802.3ck D2.1 Comment Resolution 162, 162A/C/D

Howard Heck, Intel Corporation
Chris Diminico, MC Communications/PHY-SI LLC/Panduit

Clause 162, 162A/C/D (Howard, Chris)

Rx RLcd

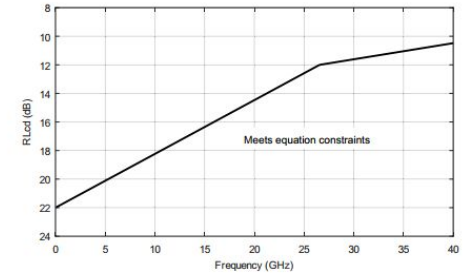
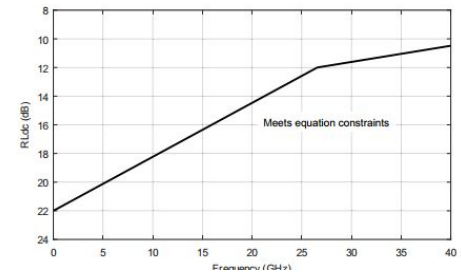
Cl 162 **SC 162.9.4.6** **P 176** **L 11** # **115**
 Dawe, Piers Nvidia
Comment Type ER **Comment Status D** *RLdc/RLcd graphs*
 Don't waste the reader's time.

Combine the graphs for Transmitter common mode to differential return loss and Receiver differential to common-mode return loss.

PROPOSED REJECT.

The two graphs represent requirements for different components, which happen in this case to have identical responses.
 [Editor's note: Change page from 175.]

Comment 94 and 79

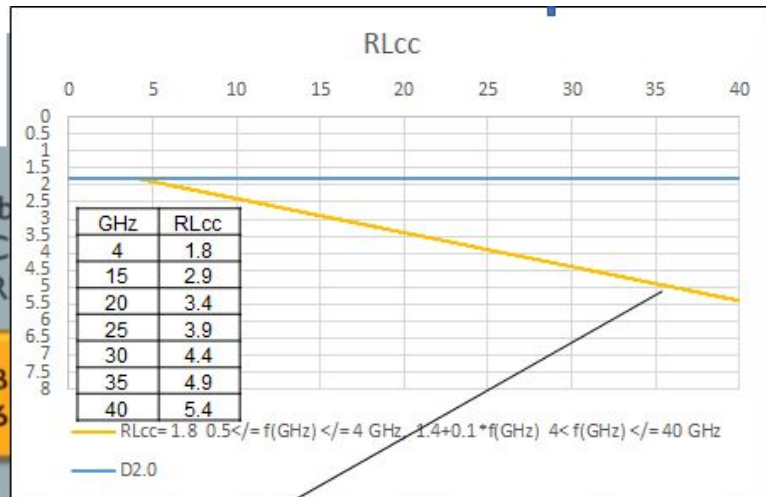
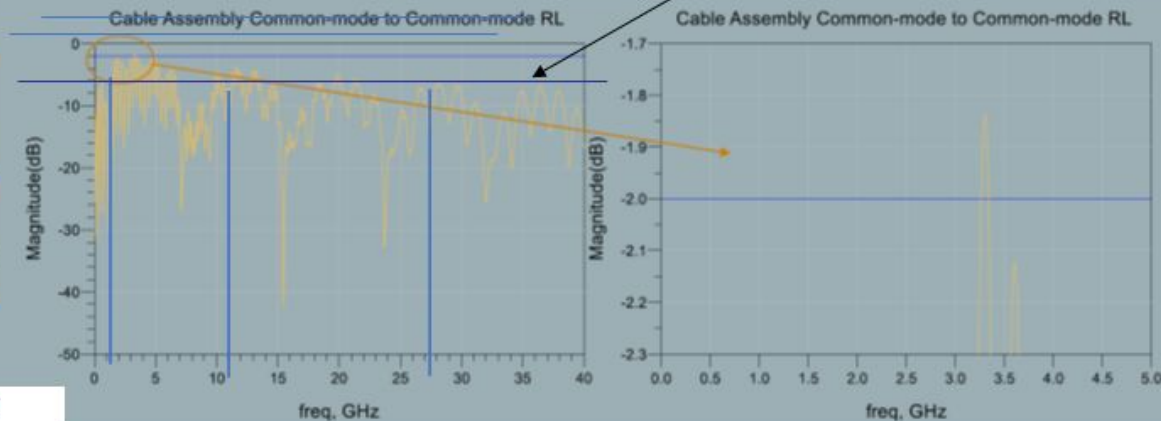
Relaxing the already very loose CM RL spec from 2 dB to 1.8 dB at all frequencies isn't justified. This draft spec becomes useless at the frequency when the MCB loss is 1.8/2 dB, which is only 8.5 GHz.

SuggestedRemedy
Use a frequency-dependent mask e.g. $1.6 + 0.01f$. Similarly for Tx, Table 162-11, 162.9.3.6.

As was pointed out in the unsatisfied comment # 177 against draft 2.0 the existing specification for common mode return loss limit effectively doesn't exist once the test fixture loss exceeds 0.9dB. The rejection however had a valid point that there is a potential issue up to 4GHz where the loss is low.

SuggestedRemedy
Change the limit to 1.8dB from 0 to 4GHz, 2.2-0.1*f from 4GHz to 40GHz.

100G CR Cu Cable OSFP channels

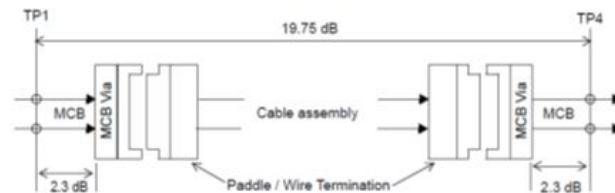
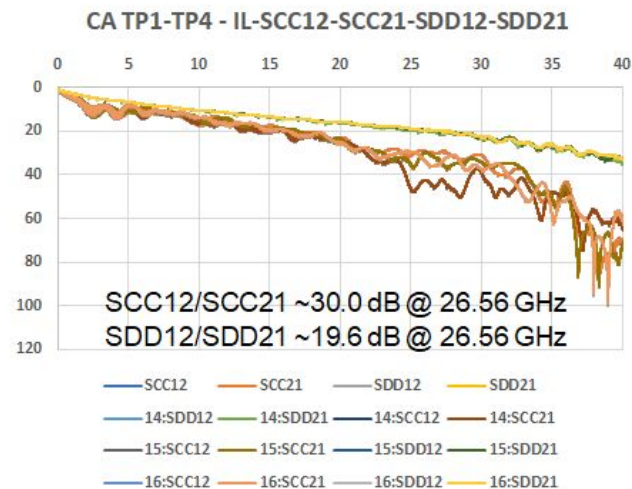
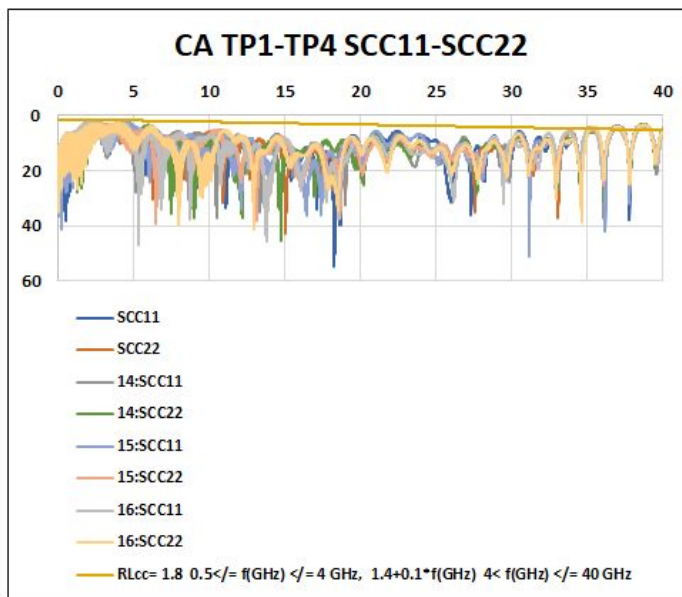
- Measurements of 2 m CA (TP1-TP4) presented
- Measurements of CA with < 2 m of same cable will exhibit worse RL scaling with cable insertion loss

Comment 108

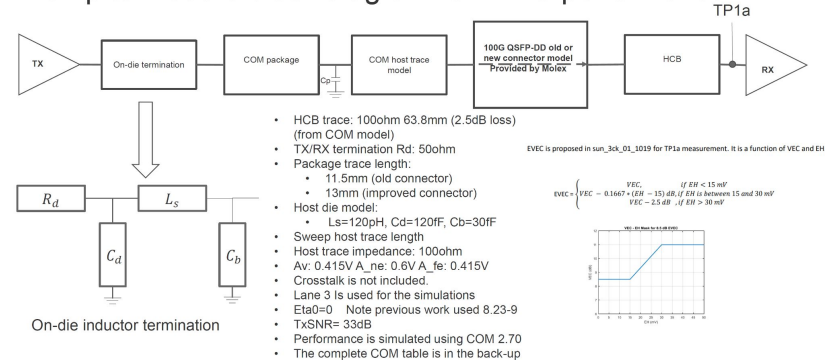
The recommended minimum insertion loss allocation for the transmitter or receiver differential controlled impedance PCBs, 2.3 dB, has been set the same as the 2.3 dB MCB PCB IL without evidence as to what happens with less loss. 2.3 dB is 1/3 of the maximum host trace loss (6.875 dB) which is too small a ratio to lay out a switch PCB. 92A.4 and 136A.4 use a ratio of 1/5.8 which allows more flexibility in host layout than 1/3 does. 120G has host insertion loss up to 11.9 dB (11.9/2.3 = 5.2/1, which is OK. If it wasn't wanted, the C2M max loss would not have been increased as it was).

Reduce the recommended minimum insertion loss allocation for the CR transmitter or receiver differential controlled impedance PCBs to whatever is justified. If the reasonable limit is a strong function of host package reflection, state whether the recommendation is for a "nominal worst" package, or what. If there is no justification, remove the recommendation.

PROPOSED REJECT.

The IL pcb min and max are derived on the basis of PCB material IL and via IL. The PCB IL assumed is 1.24 dB/in and via of 0.68 dB @26.56 GHz. With consideration for maintaining reasonable minimum length while allowing loss between TX and connector. $l_{pcb}(min) = (0.76 \text{ in} * 1.24 \text{ dB/in}) + (2 * 0.68) \text{ dB} = \sim 2.3 \text{ dB}$.

The MCB PCB IL is the same to emulate min host IL.

Lower loss hosts can also create poor performance due to reflections see the following presentation: https://www.ieee802.org/3/ck/public/20_01/dudek_3ck_01_0120.pdf
